Montrose Skatepark

Final Concept Design

DRAFT TO FINAL: KEY CHANGES

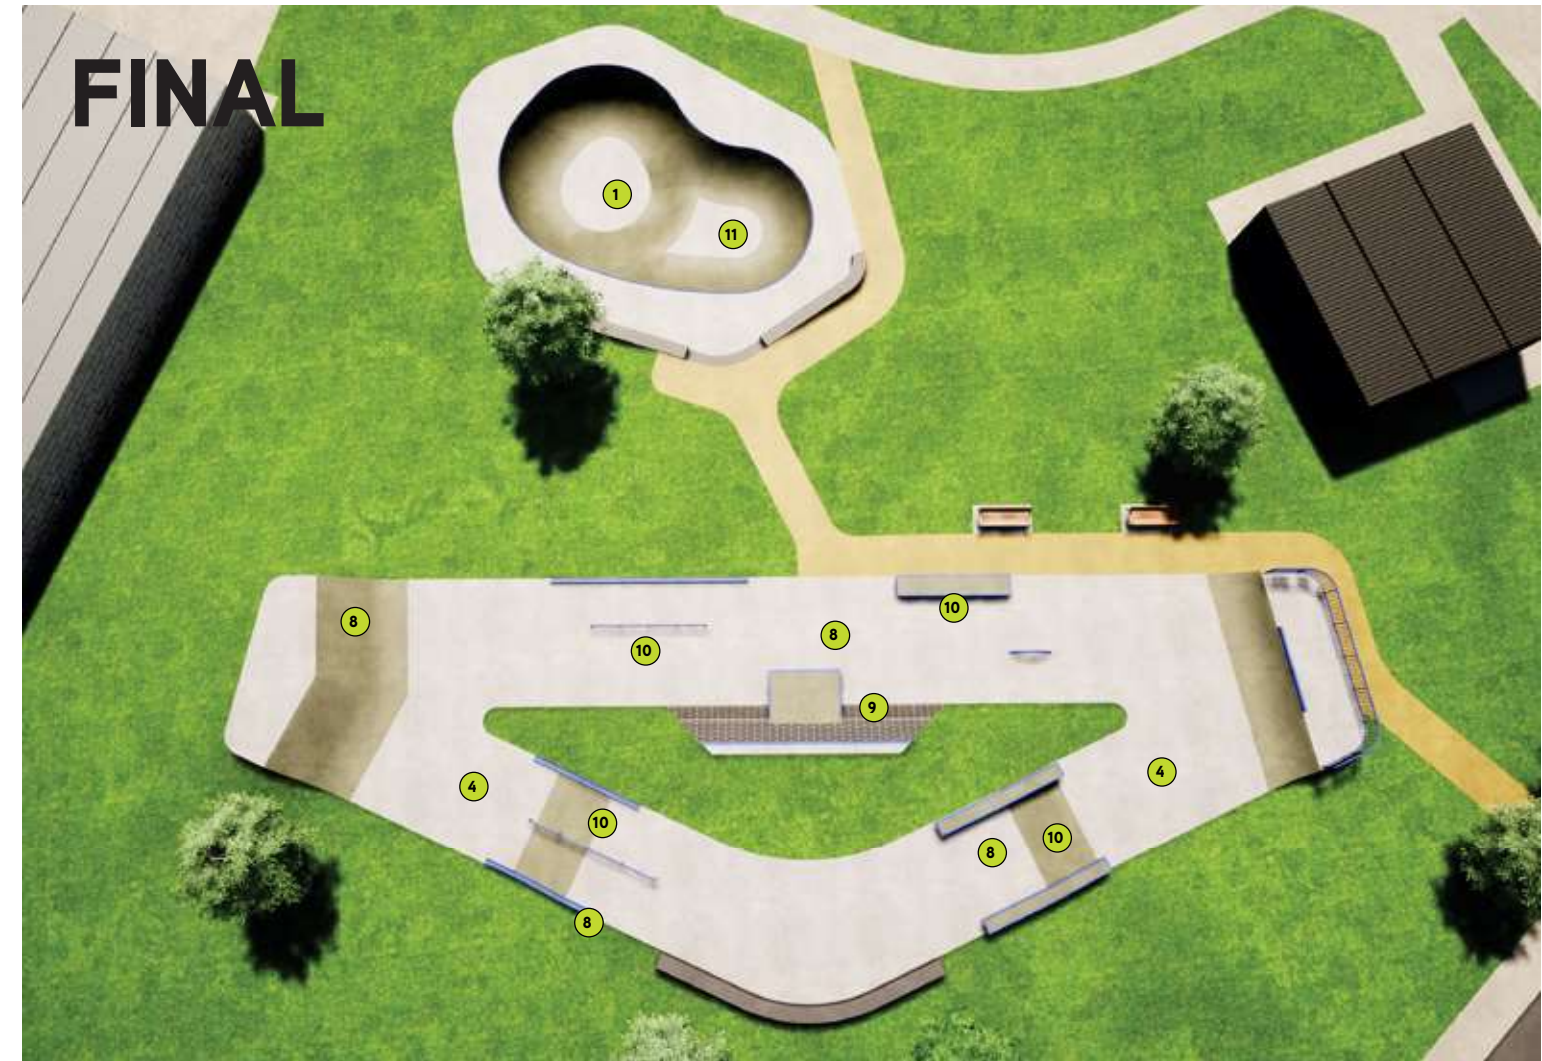
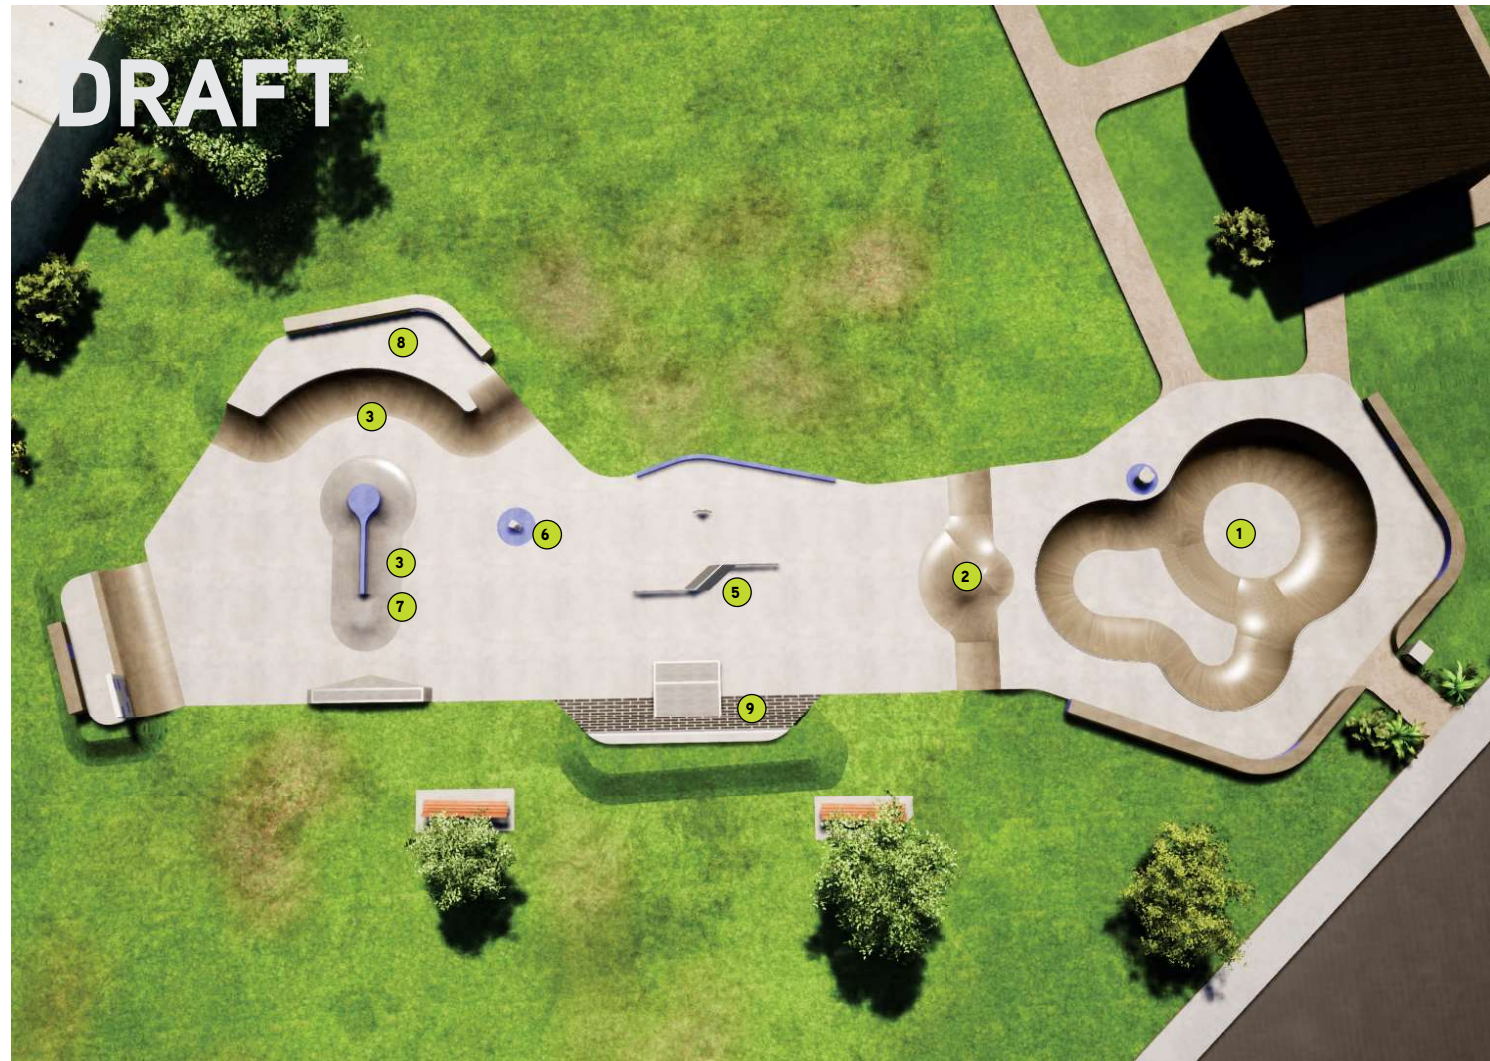
1 In general most comments around the bowl were that it was a good design however this had to be reduced to incorporate more plaza style obstacles

2 Many comments were not in favour of the bowl 'fly out' mogul and that this should be removed.

3 Overall comments suggested that the facility street run should not have transition as it is trying to incorporate too much and separates the park.

4 Most comments suggested that the region is missing plaza / street style parks and that this is needed within the area. A flowing street park was the majority comment.

5 It was suggested that the kink rail blocks flow and should be removed.

6 Many people did not like the wallie rock.

7 Many people were not in favour of the whippy spine to slappy kerb and mentioned that there are already features like this in the area.

8 People suggested that transition features such as quarter pipes should be removed and replaced with street obstacles.

9 People liked the Brick China Bank feature with many pad.

10 It was suggested that more street features be incorporated such as rails, hubbas, ledges and hips.

11 People mentioned the need for a basic mini ramp, however this can be achieved within the bowl.

12 Some people asked for a box jump, however overall the majority of people were asking for street style obstacles and it is difficult to achieve both in a small facility. (also box jumps do not work well in street style skateparks and there is one 15 minutes up the road at EC skatepark).
